PUBLIC EMPLOYEES FOR ENVIRONMENTAL RESPONSIBILITY

June 11, 2021

RE: 2021 Annual Sulfur Dioxide (SO₂) Report as Required by the Data Requirements Rule

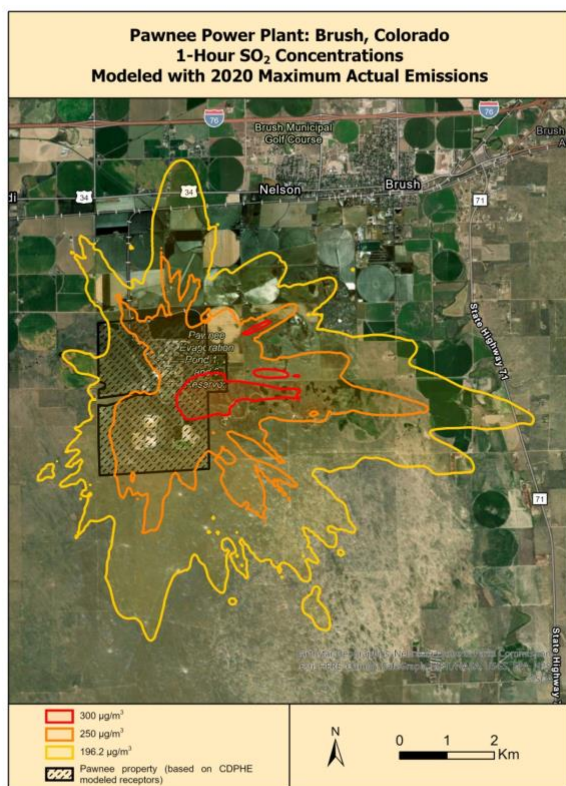
Without making any changes to the CDPHE modeling files other than replacing the original short-term “allowable” emission rate of 131.75 g/s with the maximum 2019 and 2020 actual emission rates of 583.08 g/s and 566.67 g/s respectively, the modeled results reveal that, based on 2019 and 2020 maximum actual emissions, Pawnee is in violation of the 1-hour SO₂ NAAQS both with and without background concentrations.

The results show 2073 events of violations of the 1-hr SO₂ NAAQS with the 2019 data and 1856 events with the 2020 data, with a maximum modeled concentration of 145.81 ppb, almost double the standard of 75 ppb.¹²

These results can be seen in the graphic below and in the attached modeling report.

It is important to note that a contribution analysis of all the facilities in the area are included in the modeling. It shows that all of those events of modeled violations of the 1-hr SO₂ NAAQS are caused by the Pawnee Power Plant alone, without any significant contribution from the nearby facilities. This means that all those violations will still be there, even with the drastic SO₂ emissions reductions that took place at the Western Sugar facility, as mentioned in the 2021 Report.

These modeling results constitute irrefutable evidence that the Pawnee generating station is causing violations of the 1-hr SO₂ NAAQS and that under the procedures established in the federal Data Requirements Rule, part or all Morgan County, CO should be reclassified as a nonattainment area for this health-based air quality standard.

A straight forward solution to this nonattainment situation is to incorporate the modeled emission rate of 131.75 g/s into the facility's operating permit as an hourly SO₂ emission limit. This would establish an emission rate that is truly a federally enforceable allowable emission rate that will ensure attainment with the 1-hr SO₂ NAAQS.
